<b>T.I. no.:</b> 2023-03 <b>Updated:</b> -	<b>Topic:</b> Product-Optimisation valve block
---	--

<b>Date:</b> 25.01.2023	<b>Priority</b>	<b>Need for action</b>
<b>Affected machines:</b> SCS/SOUL	High	As soon as possible
<b>From serial number:</b> -	Medium	On next visit to the machine
<b>As of date:</b> Immediately	X Low	X FYI only

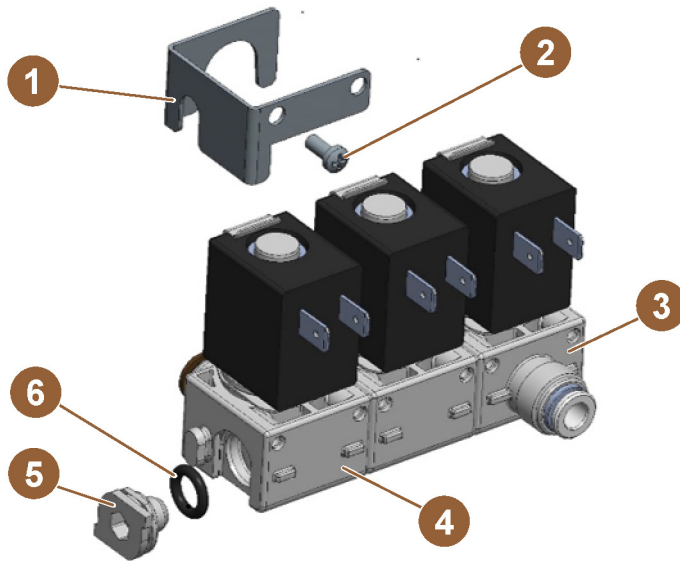
We received isolated feedback concerning malfunctioning of the end cap (33.2641.5000) of the valve assembly.

- Metal bracket 100.869 + screw 00.0047.3651 (Phillips)
- Mounted in production from 12.05.2022 onwards.
- The solution has been successfully tested with a pressure exceeding 20 bar.

Pos.-No.	Item number
1	100.869
2	00.0047.3651
3	079.211
4	079.212
5	33.2641.5000
6	33.4004.2000

### Valve mounting bracket (from production ±2018 CW30)

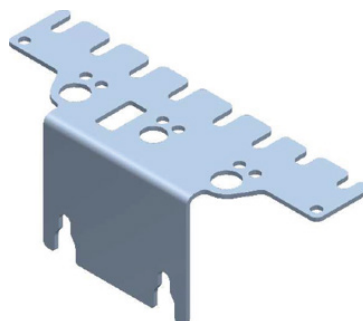
Use of this solution is possible from production ±2018 CW30; the machine must be equipped with the valve mounting bracket (right).

Bracket 100.869 (+ screw 00.0047.3651) can be used when the valve assembly is mounted on this bracket.

### Valve mounting bracket (before production ±2018 CW30)

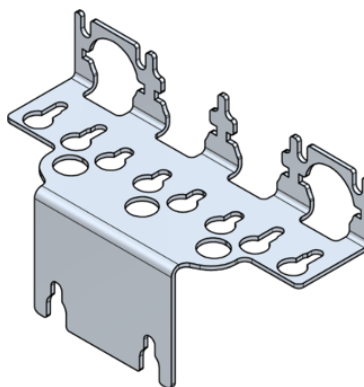
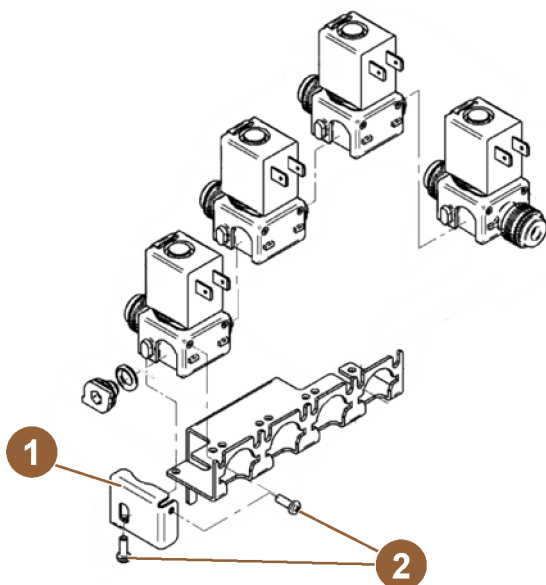
The following part numbers are required for the modification:

- 33.4335.4000 Bracket
- 00.0047.3675 Screw (PT 35x10) x 2 pcs

Bracket & Screws must be used when the valve assembly is mounted on this bracket.

Pos.-No.	Item number
1	33.4335.4000
2	00.0047.3675

The valves must be positioned at the left-hand side of the valve fixation bracket (otherwise it is not possible to mount 33.4335.4000). Due to the age of the machines the modification is not free of charge.
